## HISTORIC AND DESIGN REVIEW COMMISSION

**HDRC CASE NO:** 2024-427  
**ADDRESS:** 214 ADAMS ST  
**LEGAL DESCRIPTION:** NCB 943 BLK 1 LOT 12  
**ZONING:** RM-4, H  
**CITY COUNCIL DIST.:** 1  
**DISTRICT:** King William Historic District  
**APPLICANT:** Jaime Jimenez/Idea Studio  
**OWNER:** Maher Saloum/SALOUM MAHER  
**TYPE OF WORK:** Conceptual review of a 2-story rear addition and 2-story rear accessory structure construction  
**APPLICATION RECEIVED:** December 18, 2024  
**60-DAY REVIEW:** February 16, 2025  
**CASE MANAGER:** Bryan Morales

### REQUEST:

A4.0

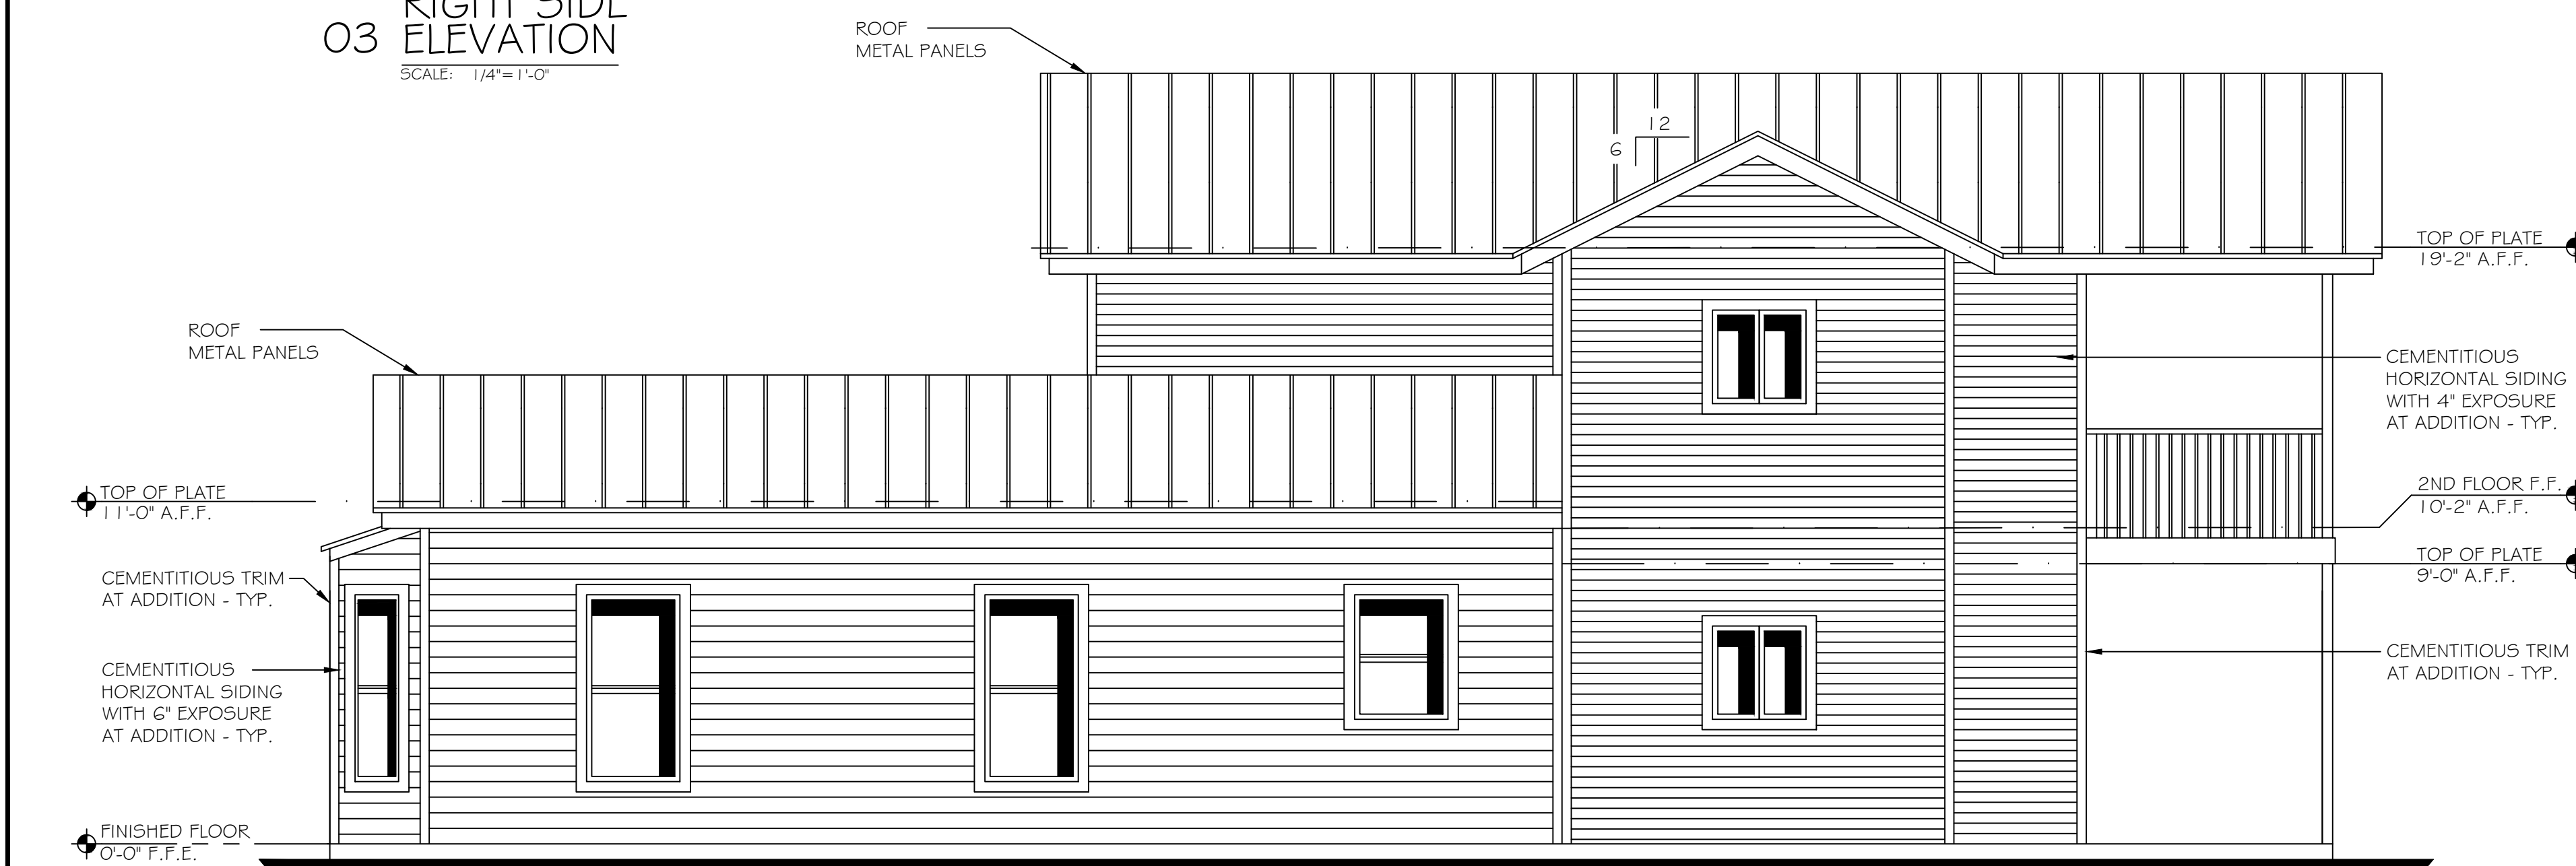
- f. REAR ADDITION (ROOF FORM) – The applicant is requesting conceptual approval to install a cross-gable roof form for the 2-story rear addition. Additions 1.A.iii stipulates that residential additions should utilize a similar roof pitch, form, overhang, and orientation as the historic structure. Staff finds the proposed roof form conforms to Guidelines.

- h. REAR ADDITION (SIDING) – The applicant is requesting conceptual approval to install fiber cement lapped siding with a 4” reveal. The existing structure features wood lapped siding with an approximate 6” reveal. Additions 3.A.i. states to use materials that match in type, color, and texture and include an offset or reveal to distinguish the addition from the historic structure whenever possible and that any new materials introduced to the site as a result of an addition must be compatible with the architectural style and materials of the original structure. Staff finds the proposed siding conforms to Guidelines; however, the proposed siding should feature a smooth finish.

- i. REAR ADDITION (ARCHITECTURAL DETAILS) – The applicant is requesting conceptual approval to construct a 2-story rear addition. Additions 4.A.ii states additions should incorporate architectural details that are in keeping with the architectural style of the original structure. Details should be simple in design and compliment the character of the original structure. Architectural details that are more ornate or elaborate than those found on the original structure should not be used to avoid drawing undue attention to the addition. Additions 4.A.iii states applicants should consider integrating contemporary interpretations of traditional designs and details for additions. Use of contemporary window moldings and door surroundings, for example, can provide visual interest while helping to convey the fact that the addition is new. Additions 2.A.v recommends that for side or rear additions utilize setbacks, a small change in detailing, or a recessed area at the seam of the historic structure and new addition to provide a clear visual distinction between old and new building forms. The applicant has incorporated a vertical trim detail between the proposed addition and historic footprint to distinguish between the old and new building forms. Staff finds the proposed rear addition’s architectural details generally appropriate.

MS: The house appears small and modest. What you are proposing seems that the massing would be seen from ROW and dominates the existing house. The design as-is may not get you an approval. JJ: The reason for where the addition is that it will be in the later addition's rear footprint. MS: How many sf are you adding. JJ: 2<sup>nd</sup> floor will be approximately 900 sf. MS: Will it be possible, when adding the second floor, instead of adding a full floor but instead do a 1.5 floor with pony walls to reduce the overall height? JJ: Understood. The main house's ceiling height is 11'. The addition's proposed height will approximately be 9'. MS: Take a look at a half story. That should help and find new ways to bring in additional light. Maybe look at adding dormers. I feel that the small house is lost.

JF: I would agree with MS. I wanted to know the plate height on the second story addition. I agree that what is drawn is overwhelming the small quant historic nature of the house. Study half walls and other methods to bring the second floor down.

Item 1: Staff does not recommend conceptual approval of the 2-story rear addition construction based on the findings. Staff recommends the applicant reduce the height of the proposed rear addition to 1-story and incorporate staff’s suggestions noted in findings a through p before returning for final review.

A5.0

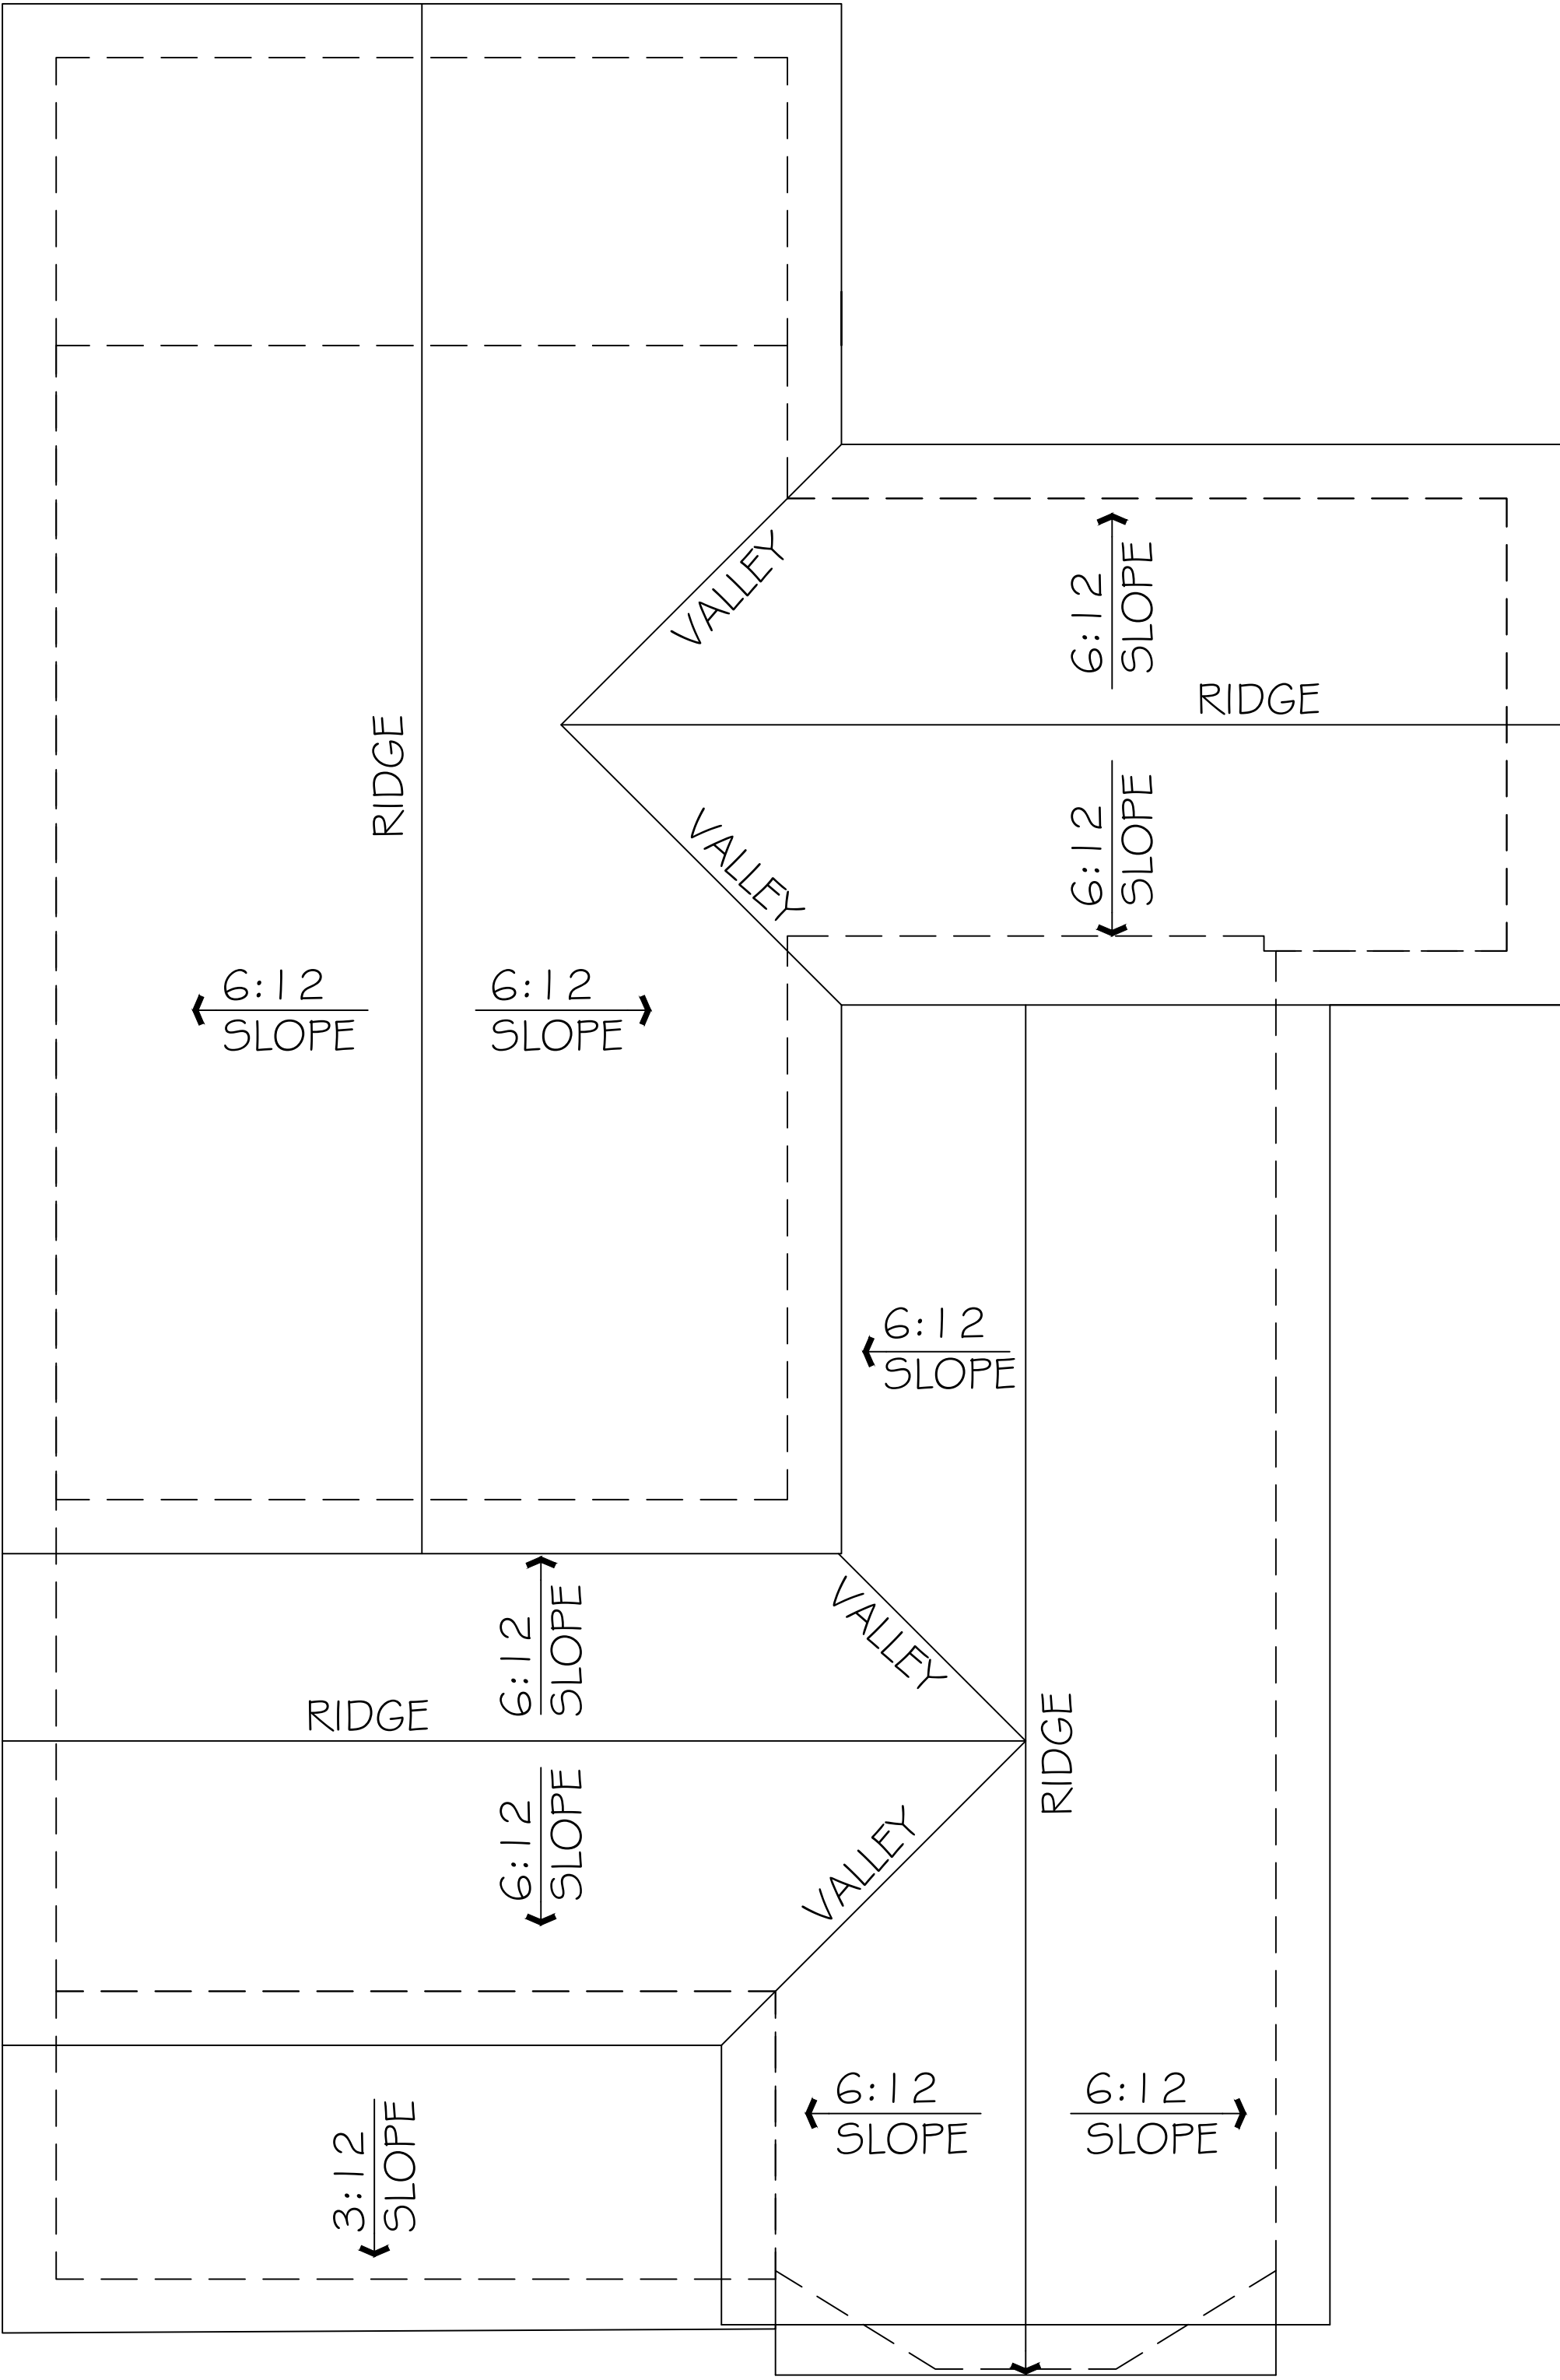
- z. ROOF REPLACEMENT – The applicant is requesting conceptual approval to replace the existing composition shingle roof with a standing seam metal roof. The Historic Design Guidelines for Exterior Maintenance and Alterations 3.B.iv. states to select a roofing material consistent with the building style when replacing a structure’s roof. Staff finds the replacement of the roof with a standing seam metal roof generally appropriate.

Item 3: Staff recommends final approval of the composition shingle roof replacement with a standing seam metal roof based on the findings, with the following stipulation:

- i. That the applicant install a standing seam metal roof featuring panels that are 18 to 21 inches wide, seams that are 1 to 2 inches high, a crimped ridge seam, and match the current finish or a standard galvalume finish. Panels should be smooth without striation or corrugation. Ridges are to feature a double-munch or crimped ridge configuration; no vented ridge caps or end caps are allowed. All chimney, flue, and related existing roof details must be preserved. An inspection must be scheduled with OHP staff prior to the start of work to verify that the roofing material matches the approved specifications. No modifications to the roof pitch or roof form are requested or approved at this time.
